**Lupin House**

Response to Camden Planning Department

05 August 2022

Ground Floor Plan

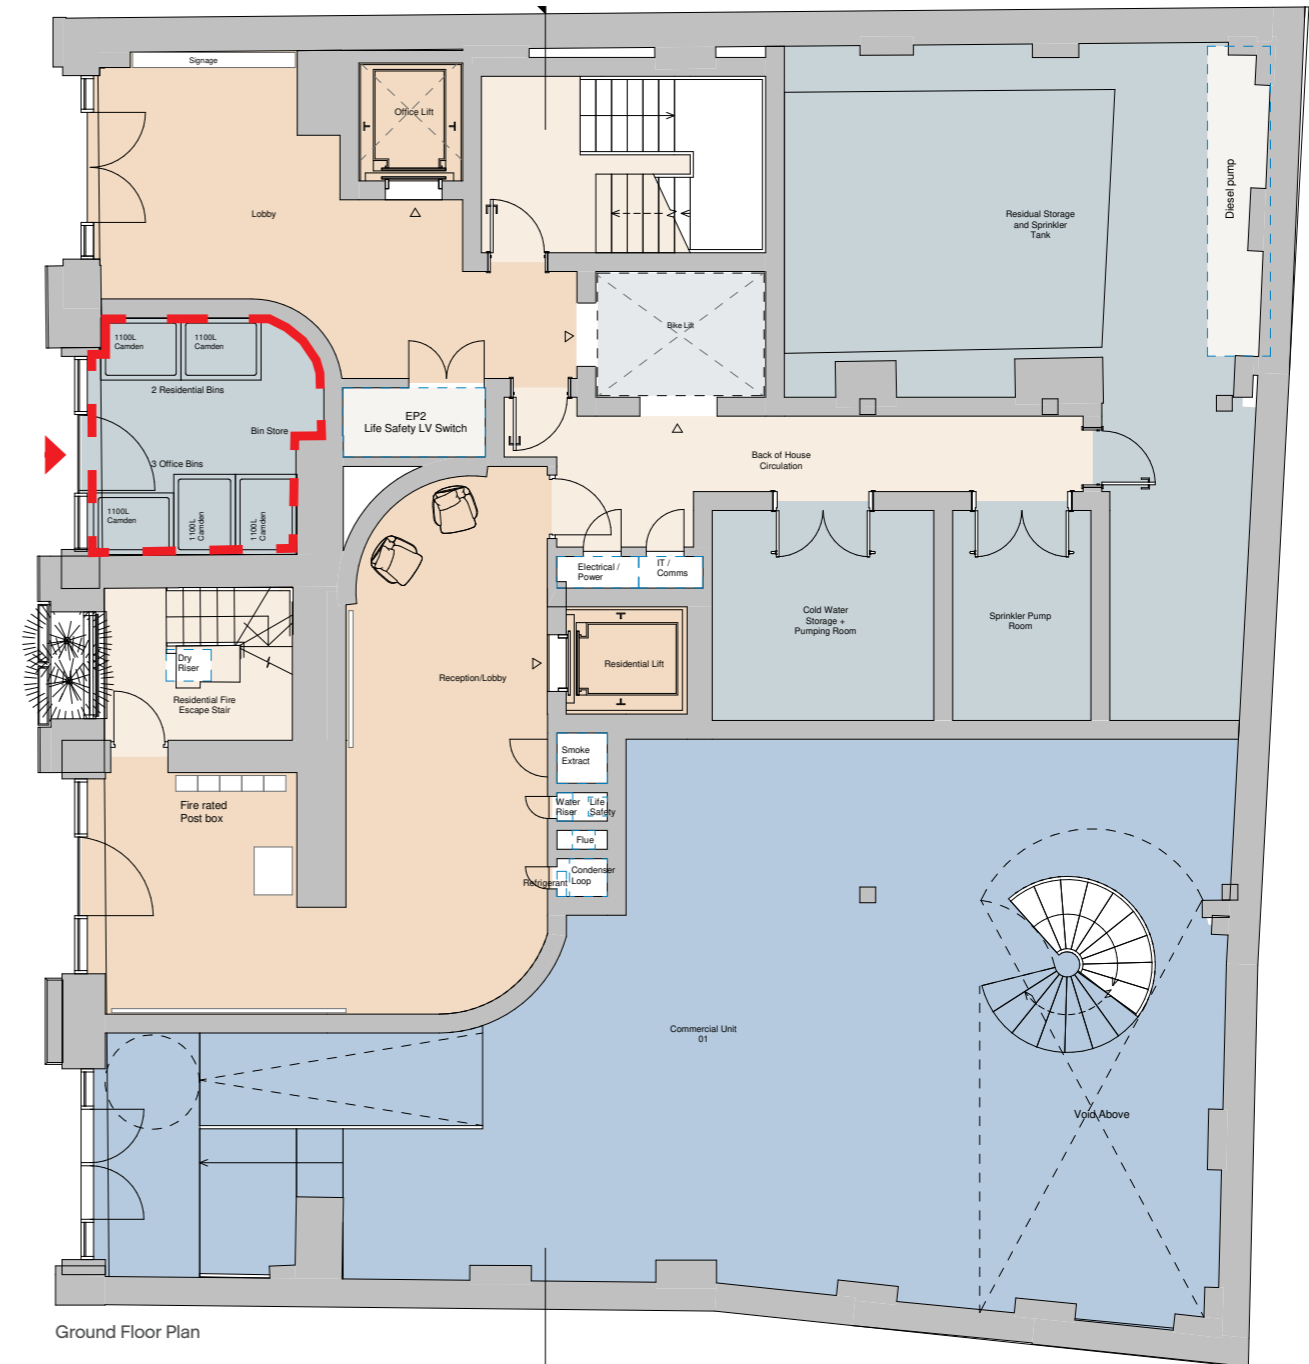
- The bin stores to be separated between the uses, officers would be unlikely to support this shared arrangement.

In order to minimise the distance that a bin will be dragged from the store when being collected we have located the bin store on the front facade.

Due to the historic nature of the front facade it would not be suitable to provide two bin stores, giving them prominence in the historic streetscape, therefore we have combined the store to contain both commercial and residential bins, clearly labelled. This proposal is an improvement to the existing waste facilities on the site.

Paragraph 8.29 in the CPG: Design reads: "Commercial units should generally have their own independent waste and recycling store and this must be separate from any residential bin stores. **Where the same service collection provider collects it may be possible to apply for a permit or waste exemption for shared bin storage for certain types of waste produced, i.e. mixed recycling or general waste**".

The same collection provider will be used for both commercial and residential waste.

Accessible bike routes on Ground Floor

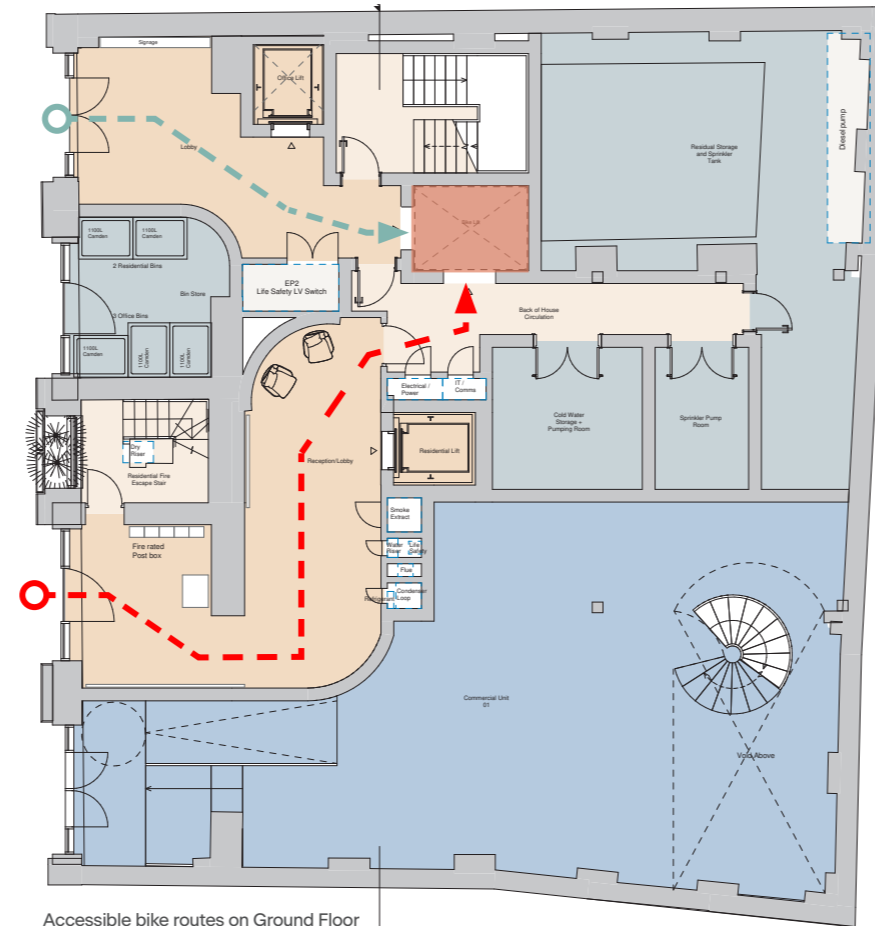
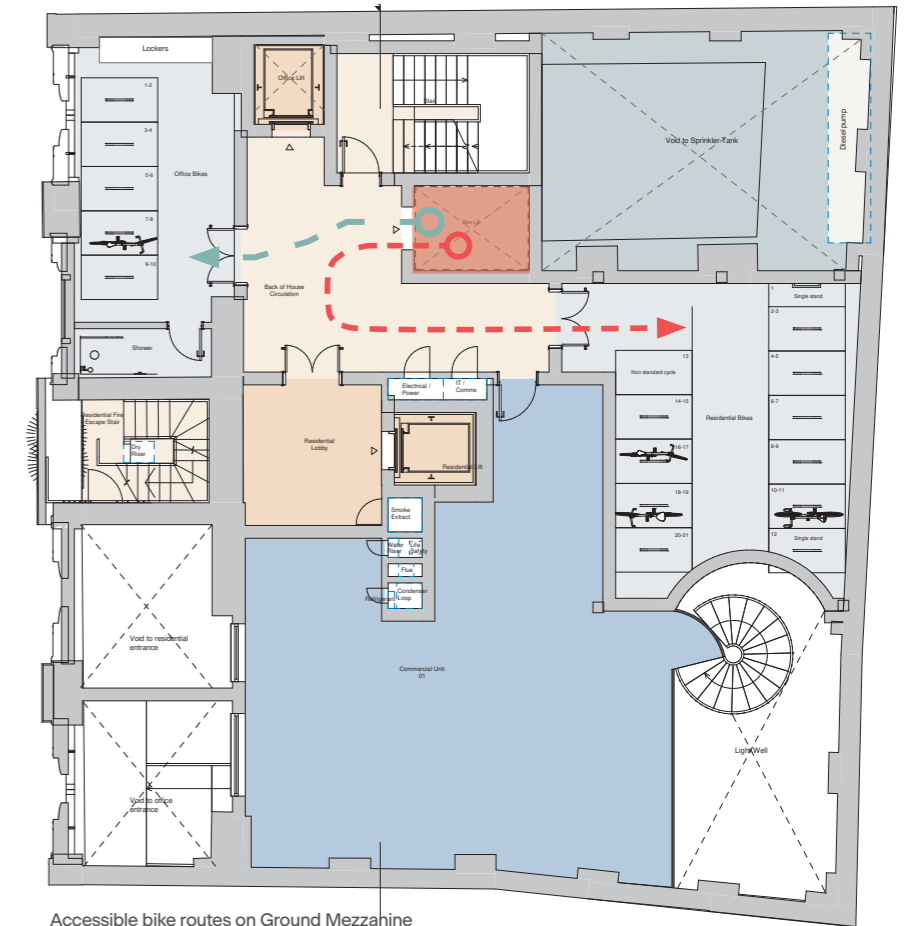
- Very concerned about the shared entrance for both residential and office just to be able to access the cycle parking, high potential for crime and ASB through a conflict of uses. This should be designed out by putting one of the cycle stores at ground floor.
- The current layout would also require destination control on the lifts and stairs to prevent access to floors unrelated to them.

There is not a shared entrance for residential and office, each has a separate entrance with separate route to the bike lift as annotated opposite. The two bike stores on the mezzanine level are separate, with access controlled security doors.

Destination control will be provided to the lifts, and access control to the stair doors.

Ground Floor Sketch - rejected option

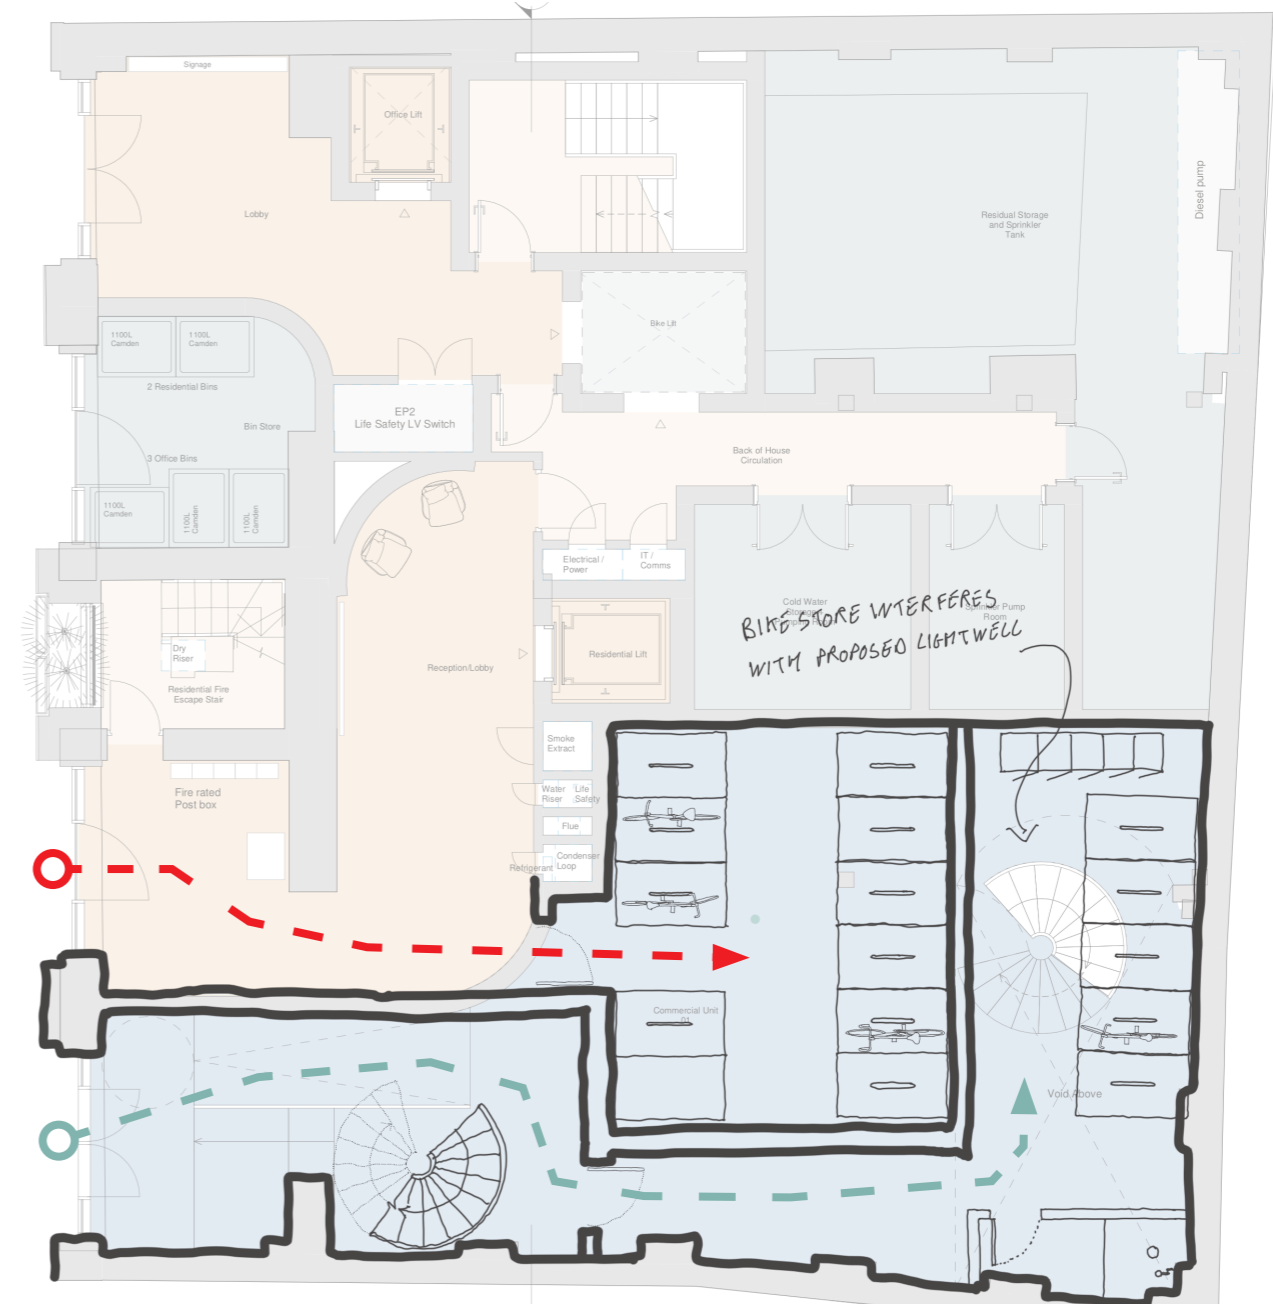
- The Council would stress that cycle parking should be at ground floor level if feasible particularly the residential store as this would mean that they would not need to have access to the mezzanine level or the cycle lift. This would also address the designing out crime issues below.

It is not feasible to swap the bike stores on the mezzanine with the plant areas on the ground floor as the technical constraints of the plant require it to be on ground level.

If the bikes are moved down to the ground level along with the plant area it takes up the majority of useable space from the office, blocking access to the new lightwell which was added to improve the quality of office space. Refer to sketch opposite, which was a design option rejected by the design team.

Given the importance of high quality office space and the efforts made in the scheme to provide that, it was considered inappropriate to sacrifice office space for bike storage which can be provided more appropriately elsewhere in the building.
